This Service Information bulletin supersedes SI B61 13 06 **dated February 2009.**

Various Electrical Problems Caused by Water Ingress

E60 (5 Series)

3. Smoke Test

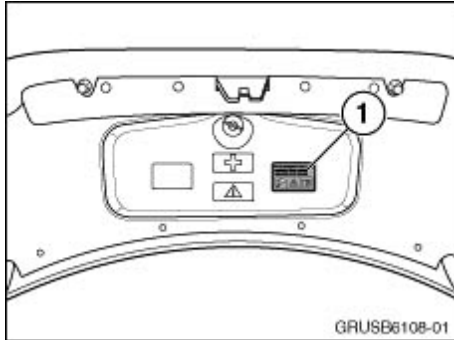
NOTE: The following smoke test should be performed with the interior trunk trim removed, the rear bumper cover removed, and the vehicle on a lift. The VACUTECH® Smoke Machine or equivalent may be used for this procedure.

- a. Fold down one side of the split folding rear seat; insert the smoke machine nozzle into the trunk, and then fold the seatback up.
- b. Turn the smoke machine on and allow the trunk to fill with smoke.
- c. After 5-10 minutes, the trunk will be completely filled; if any water paths exist, they should be visible on the outside of the vehicle.
 - NOTE: Disregard the small amount of smoke which will come out of the air extractors.
- d. Closely inspect the areas around the following:
 - Trunk lid
 - Quarter panels
 - Lower rear tail panel around the bumper supports
 - Side panels around the air extractors
 - Floor pan up to the front of the rear sub-frame
- e. Repair the leaking area as necessary.
- f. If no leaks are found after smoke testing the trunk, continue with the following repair.
